ADDENDUM NO. 04 (MEPT)

Date of Issuance: April, 23, 2026

Project: **Replacement Elementary on Mustang Rd.**
Alvin Independent School District

Texas Arcadis Inc.
Project No.: 202502 - 30268973

ELECTRICAL
LIGHTING PLAN -
LEVEL 1 AREA - A1

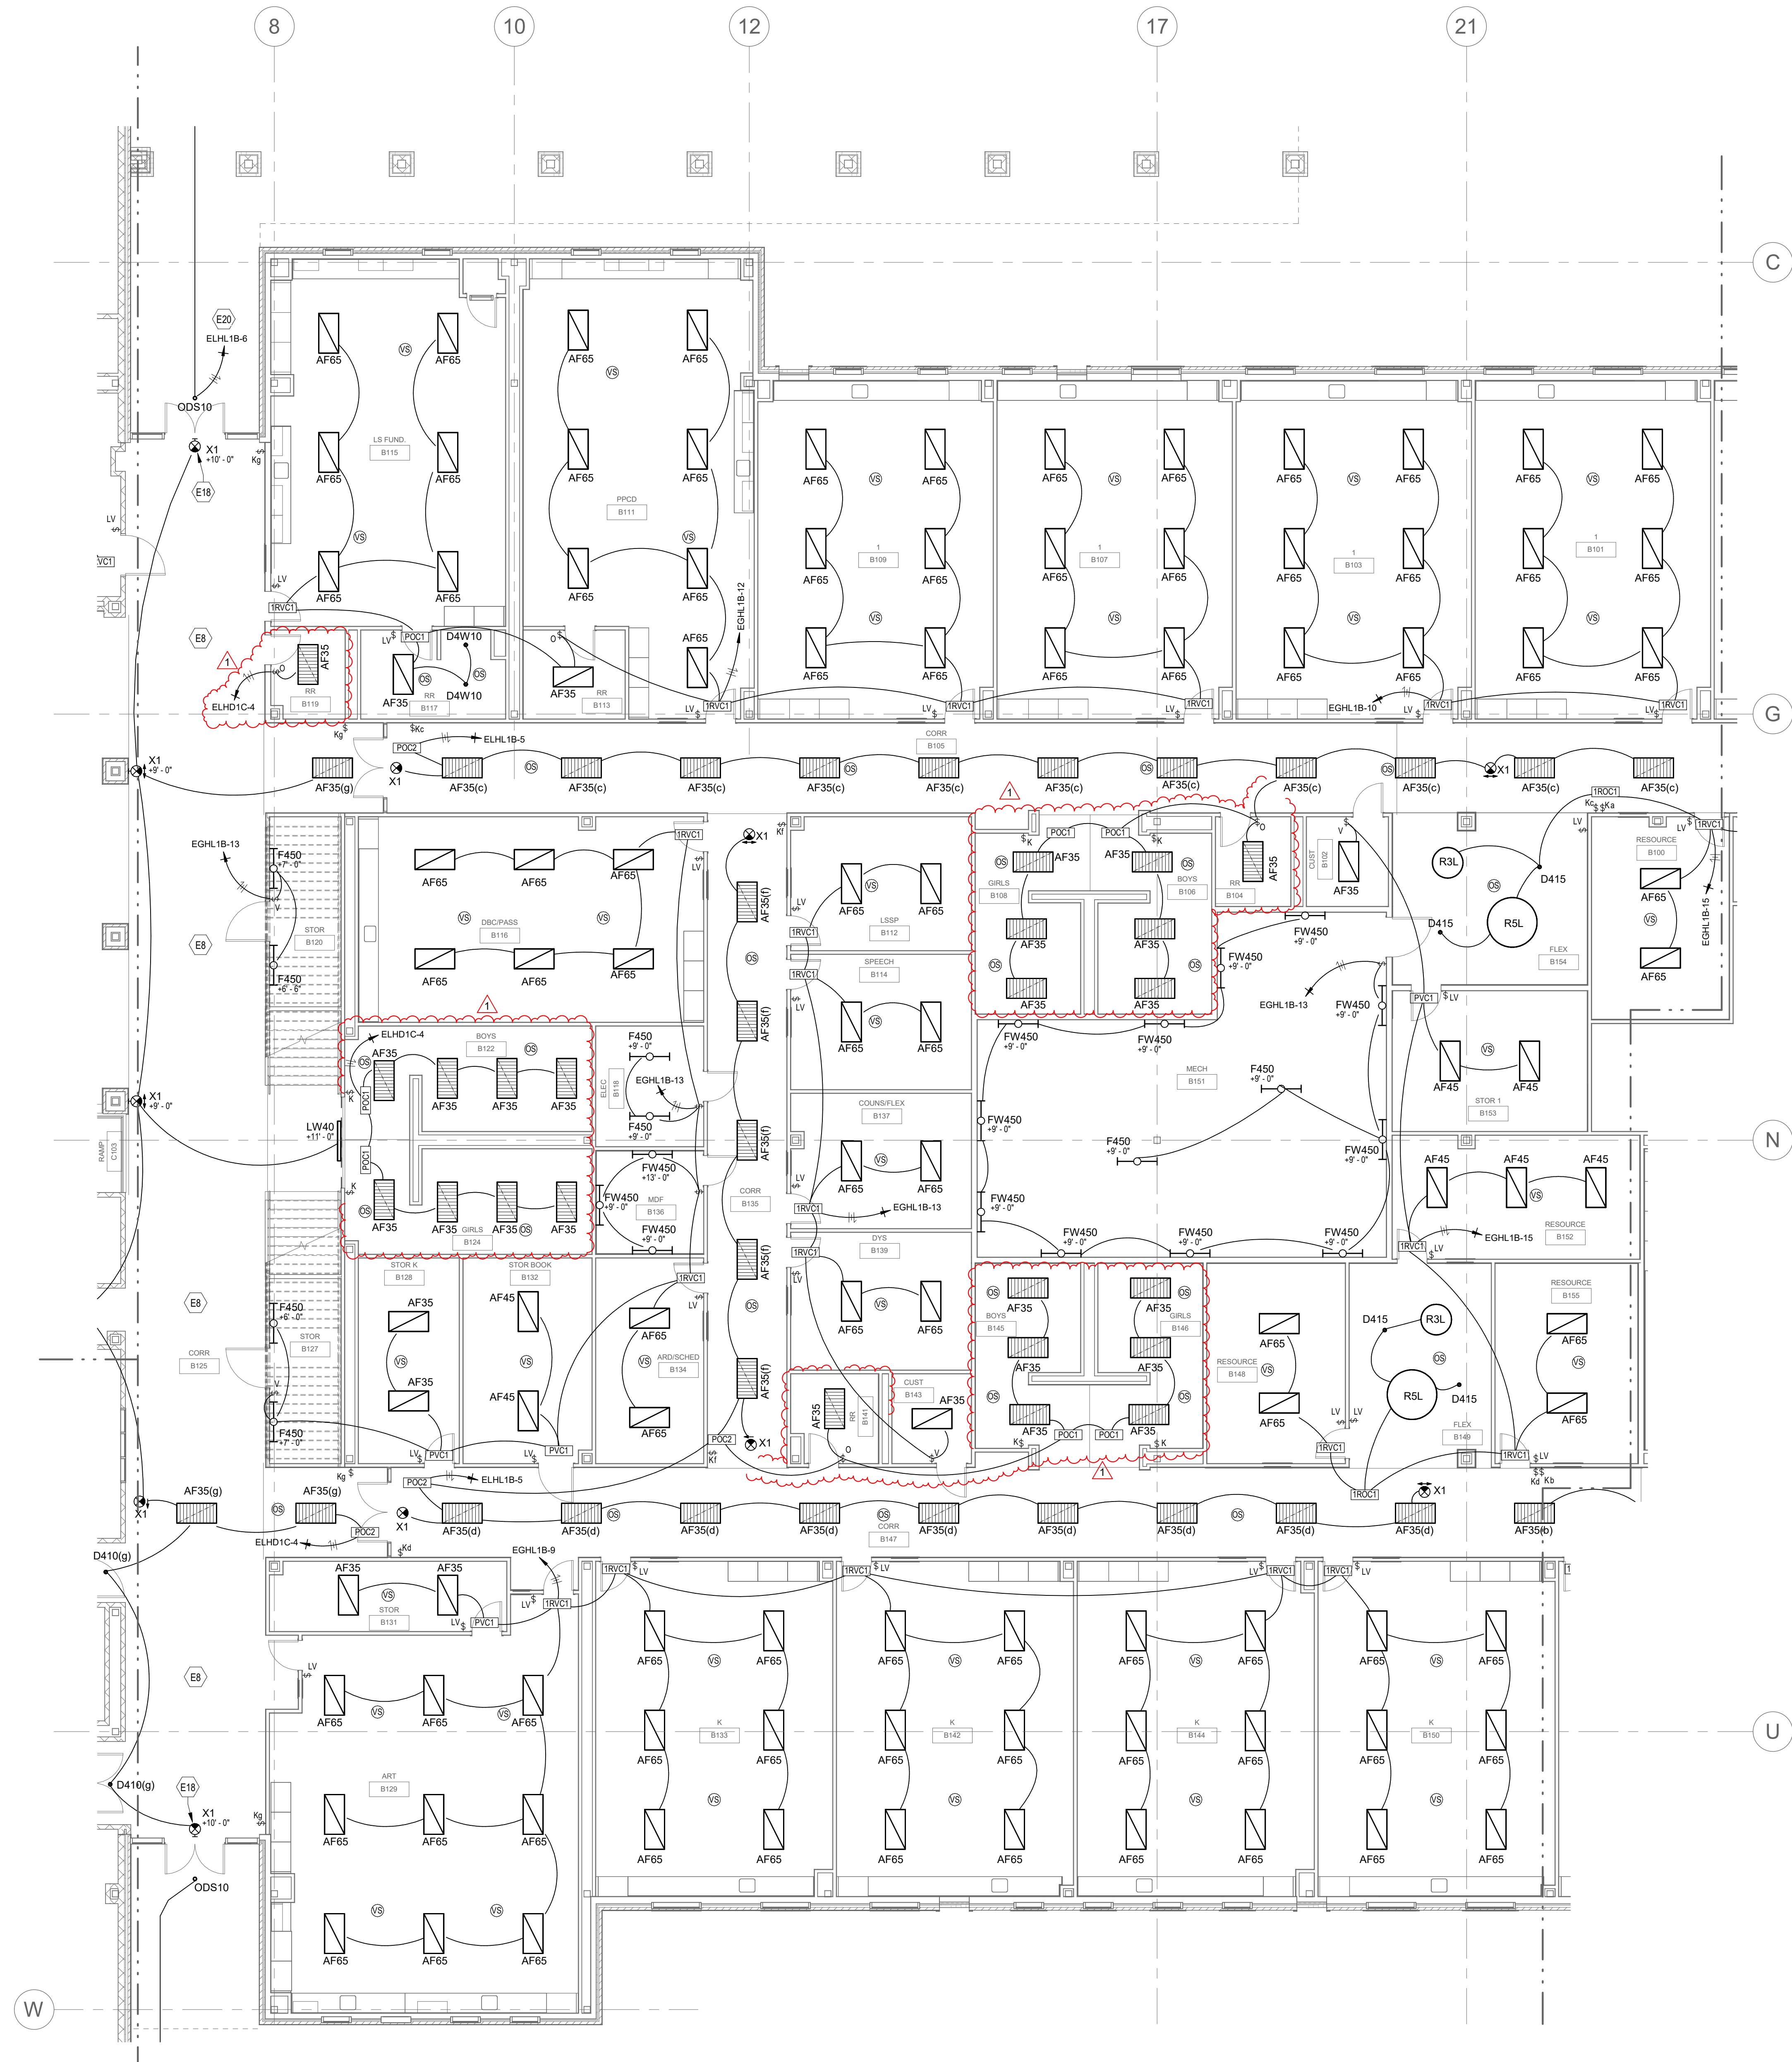
- c. Added additional information for Single Duct CAV Runout schedule.
- 50. Sheet E3.01 – ELECTRICAL LIGHTING PLAN – LEVEL 1 AREA – A1
 - a. Lighting in single restrooms A104 and A156 moved to life-safety circuit. Life-safety hatching shown.

- b. Exit signs in clinic moved to life-safety circuit.
- 51. Sheet E3.02 – ELECTRICAL LIGHTING PLAN – LEVEL 1 AREA – B1
 - a. Lighting in gang restrooms and single restrooms B104, B141, and B119 moved to life-safety circuit.

1 ELECTRICAL PLAN - LIGHTING - LEVEL 1 AREA - C1
1/8" = 1'-0"

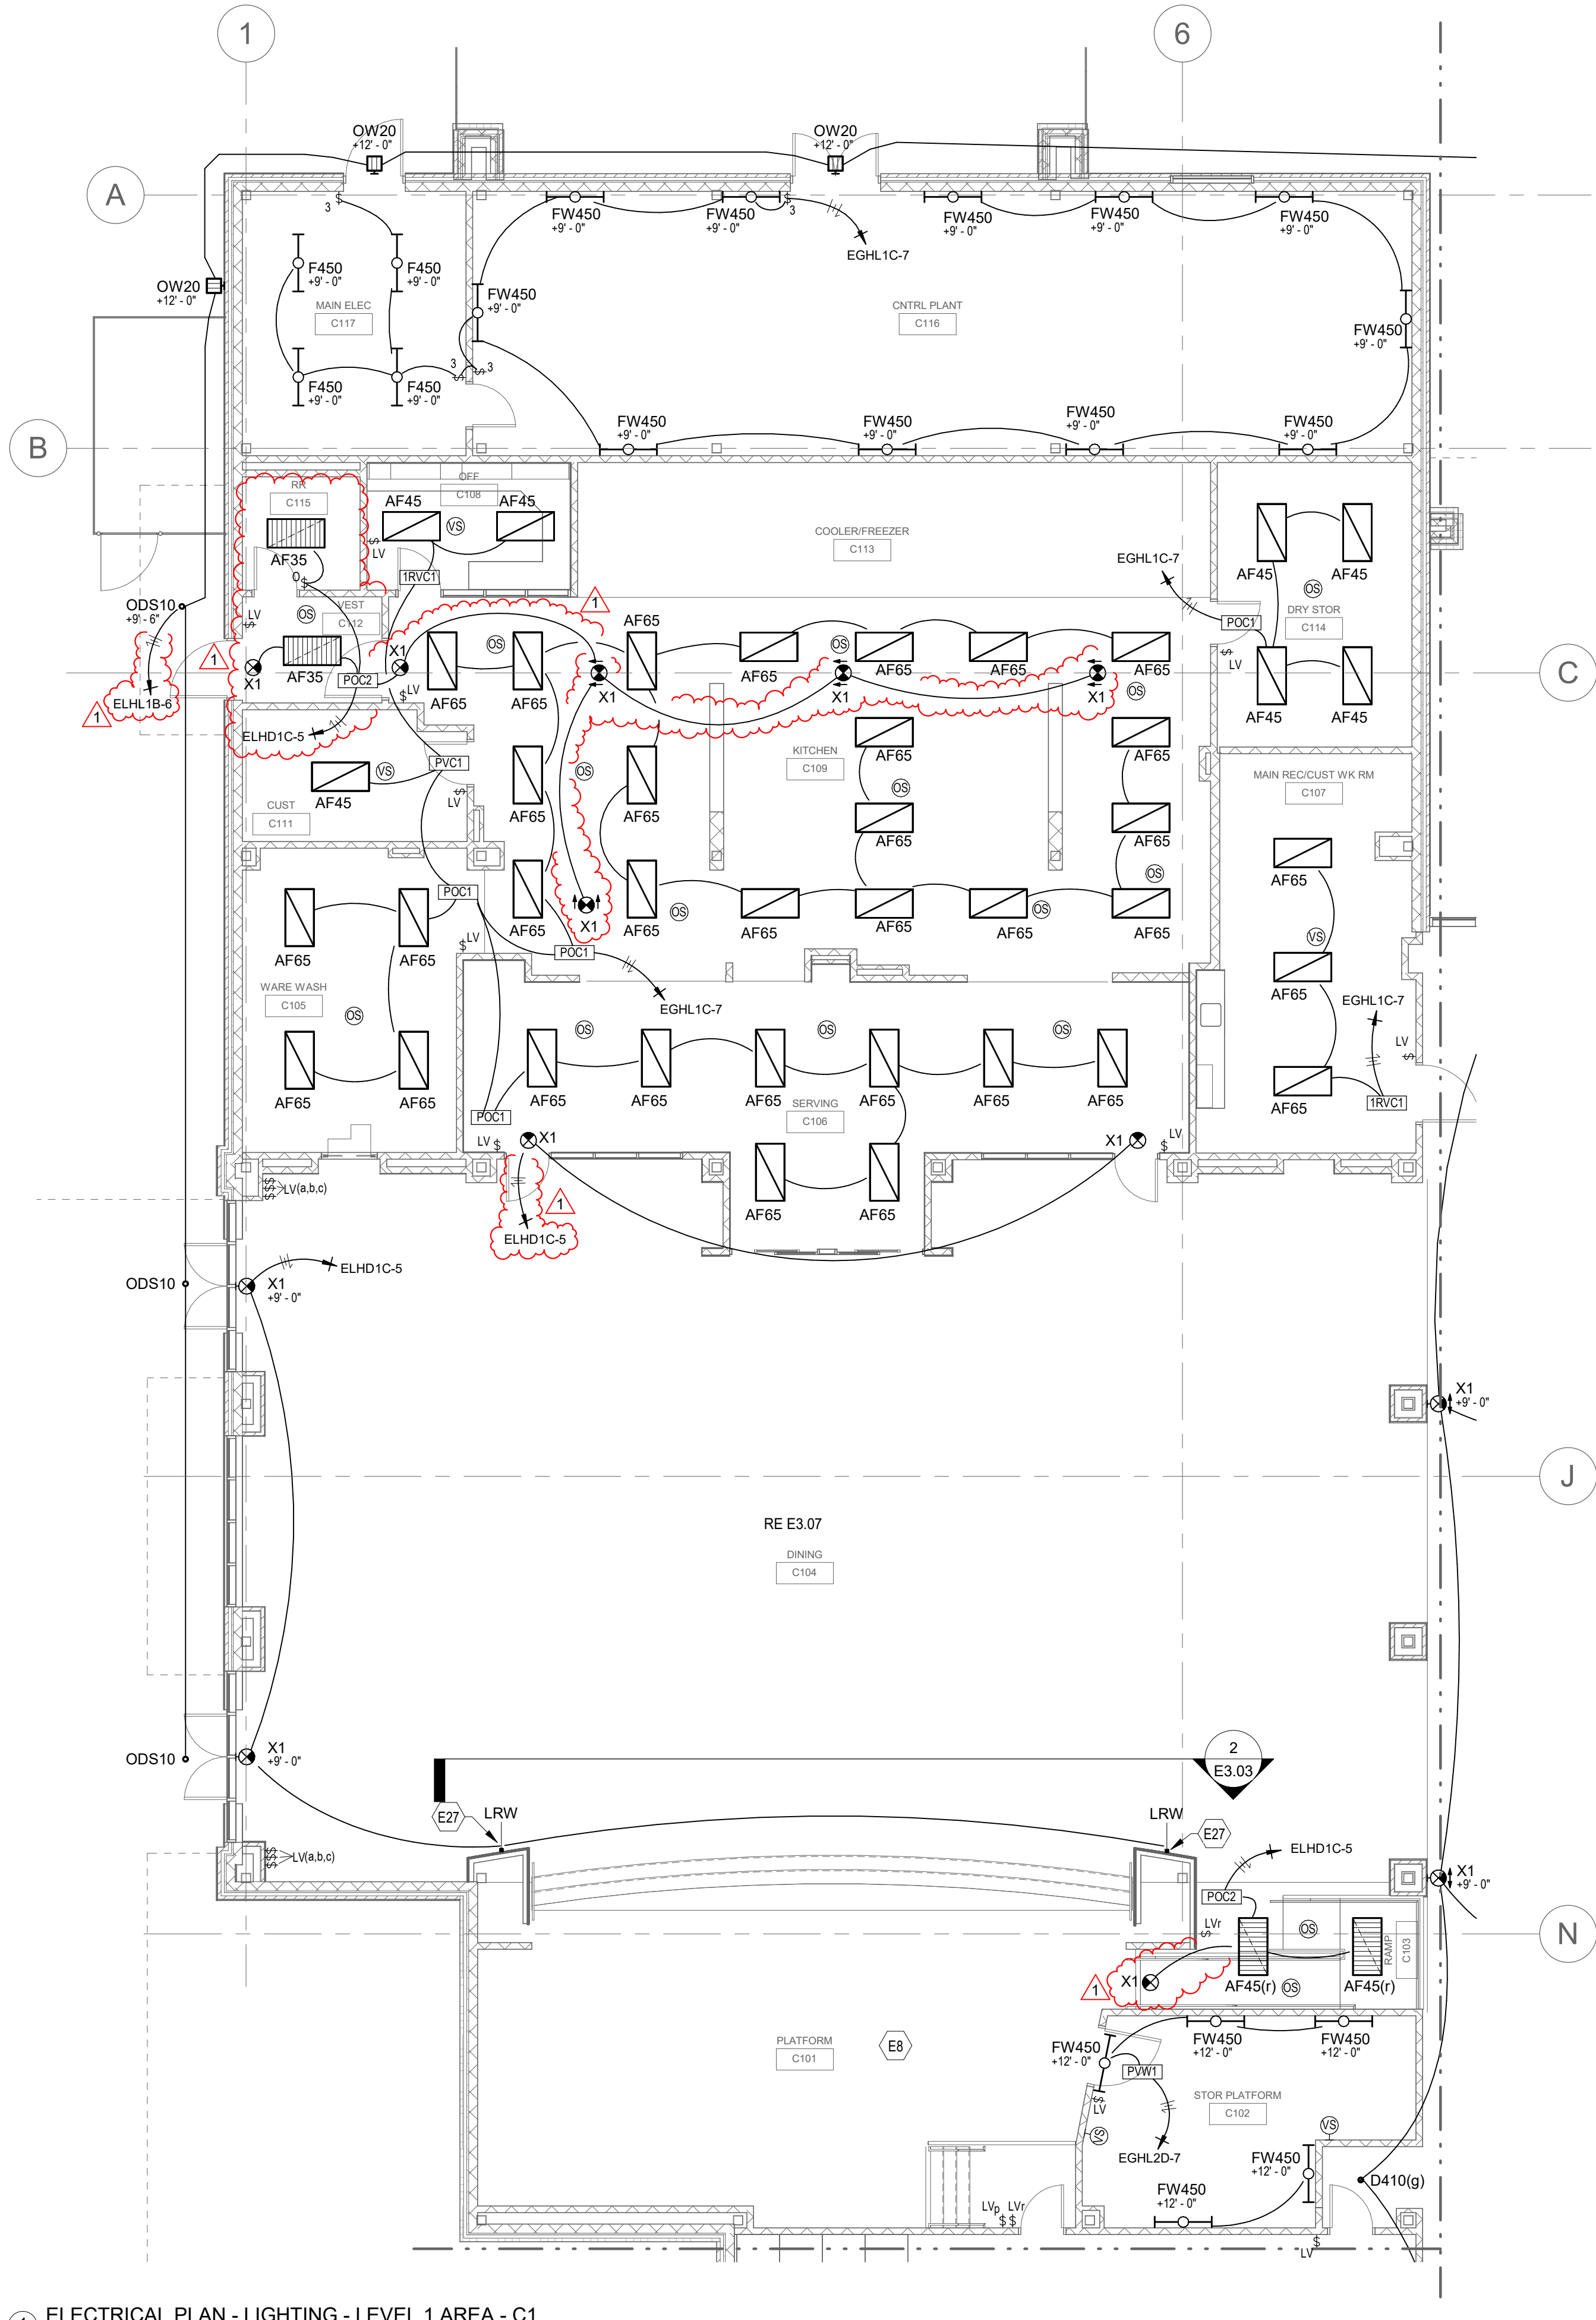
- 52. Sheet E3.03 – ELECTRICAL LIGHTING PLAN – LEVEL 1 AREA – C1
 - a. Lighting in kitchen vestibule and single restroom C115 moved to life-safety circuit.

- b. Exit signs in kitchen and serving moved to life-safety circuit.
 - c. Home-run shown for exterior lighting on life-safety circuit for reference.
 - d. Exit sign added at platform ramp and added to nearby life-safety circuit.

1 ELECTRICAL PLAN - LIGHTING - LEVEL 2 AREA - A2
1/8" = 1'-0"

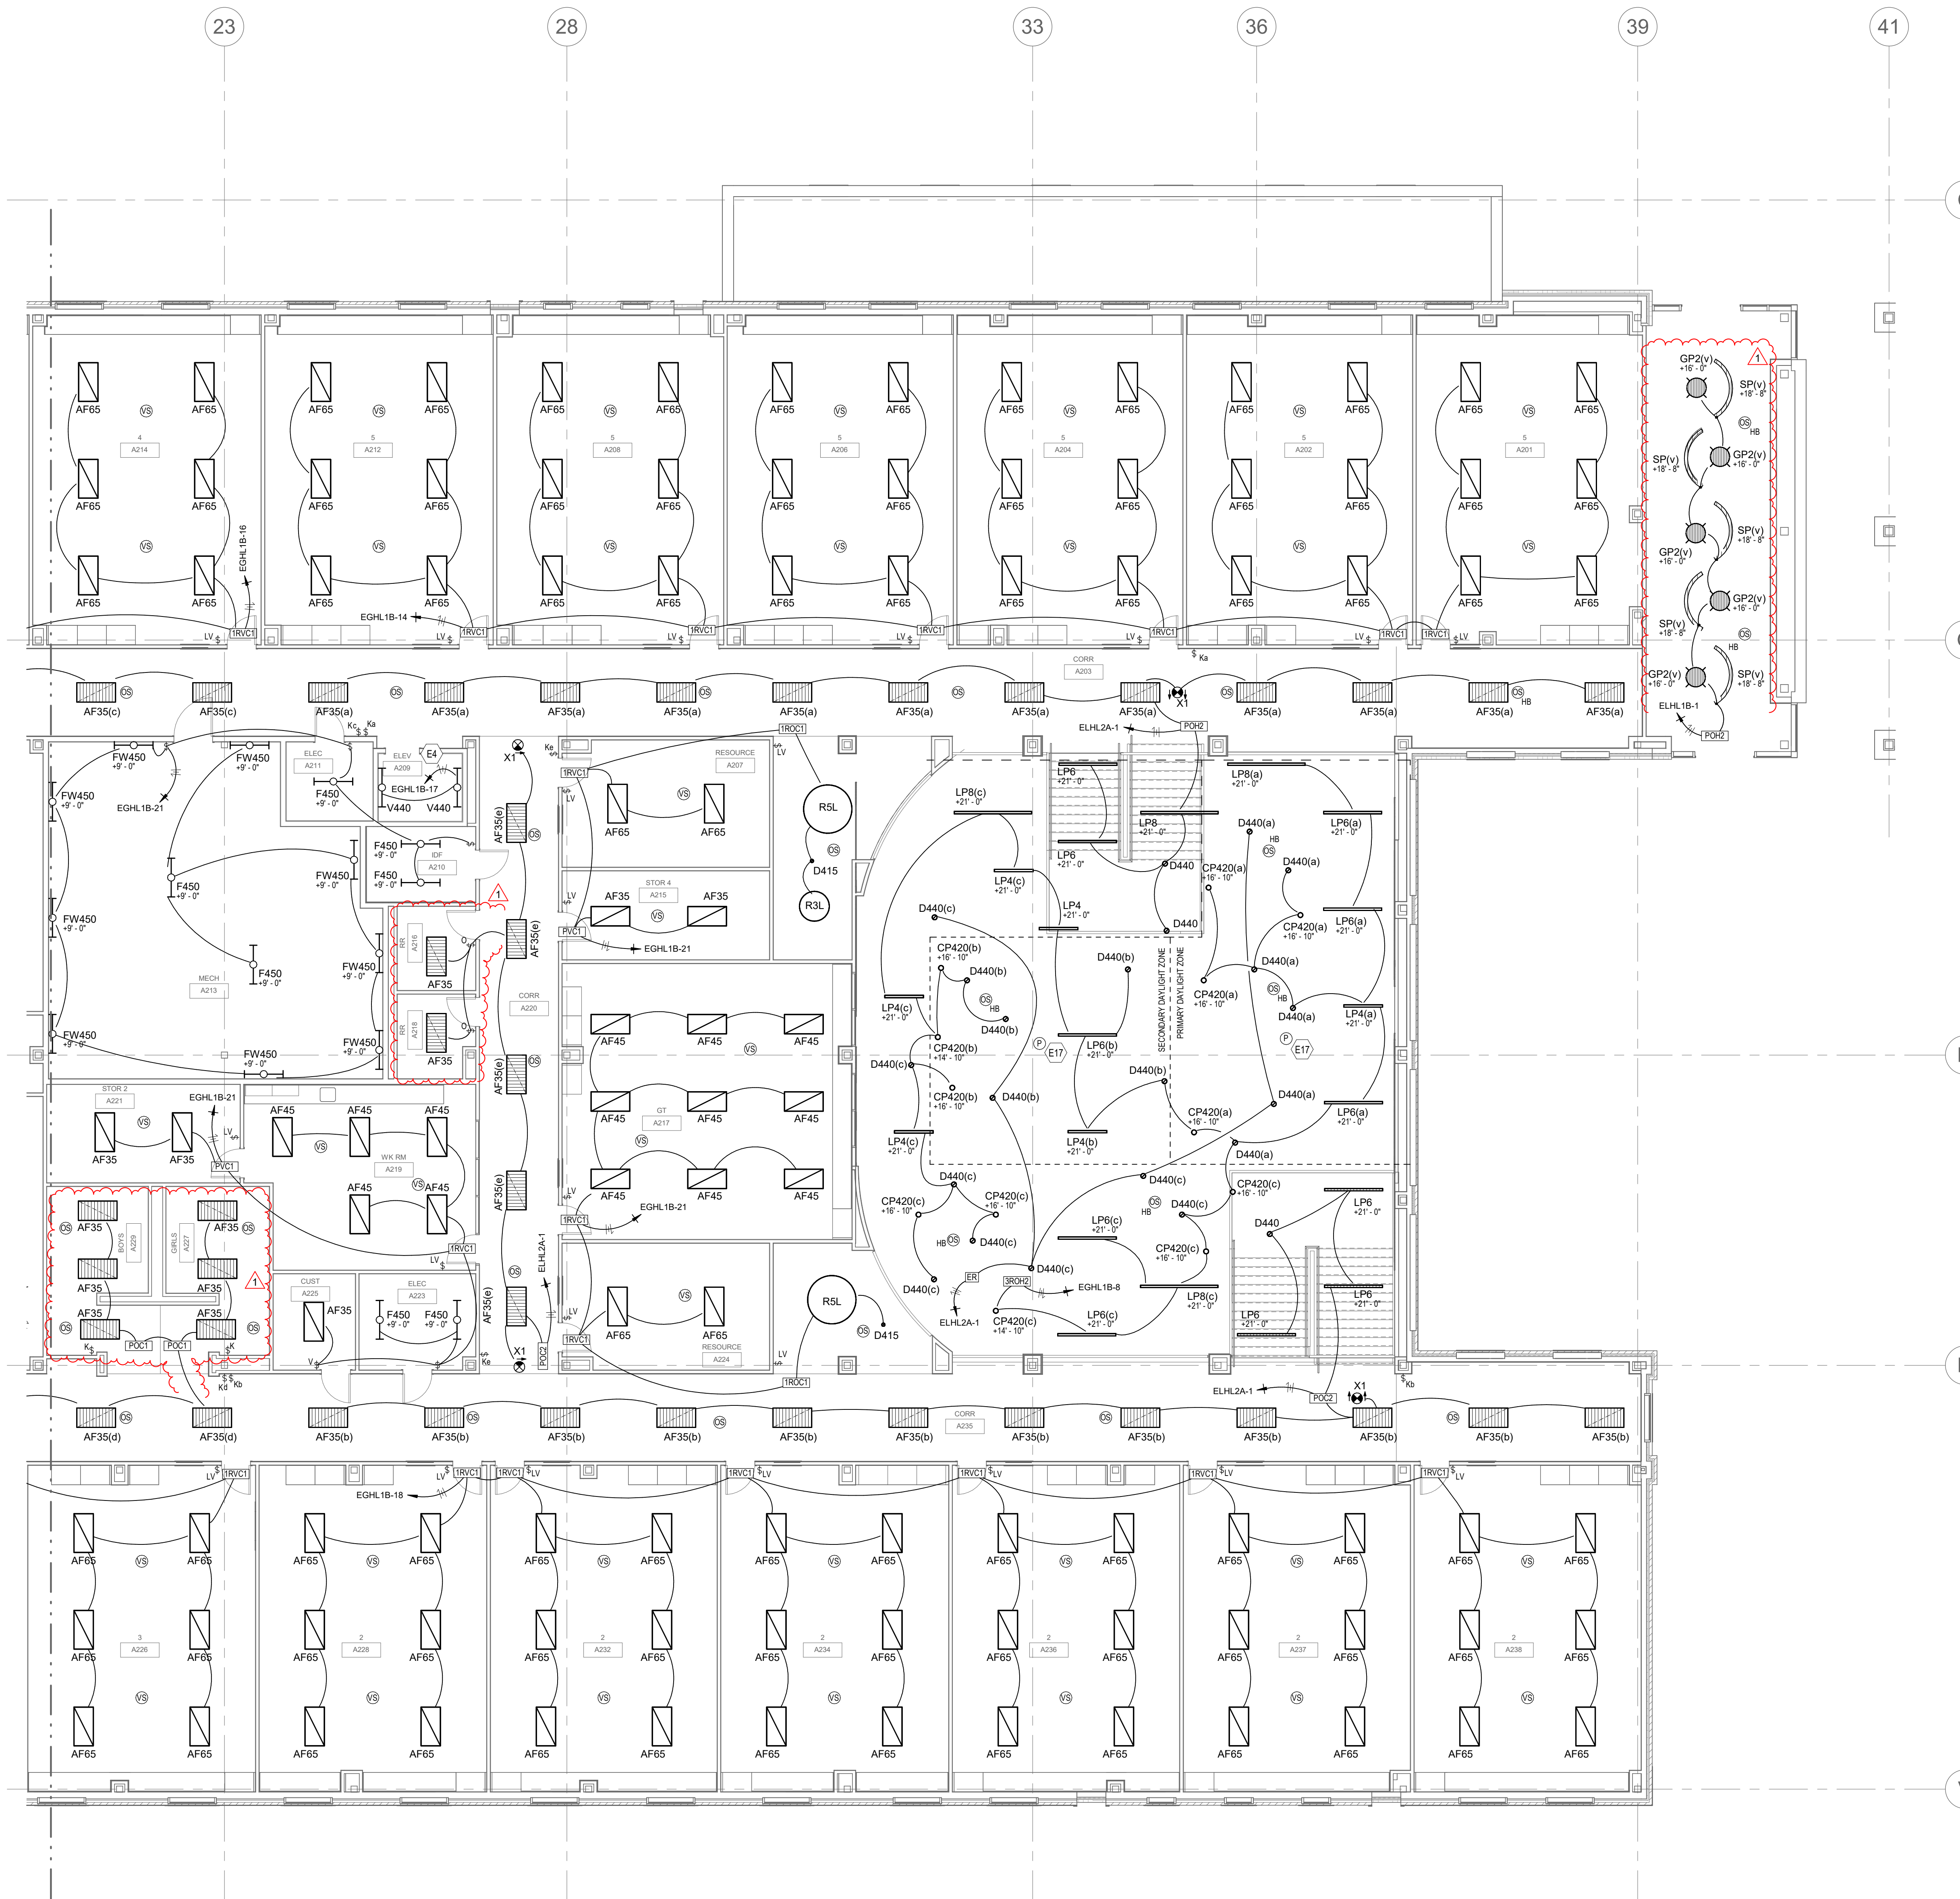
- 53. Sheet E3.05 – ELECTRICAL LIGHTING PLAN – LEVEL 2 AREA – A2
 - a. Light fixtures in vestibule shown with life-safety hatching for reference. Lighting already connected to life-safety.

- b. Lighting in gang restrooms and single restrooms A218 and A216 moved to life-safety circuit.
- 54. Sheet E3.06 – ELECTRICAL LIGHTING PLAN – LEVEL 2 AREA – B2
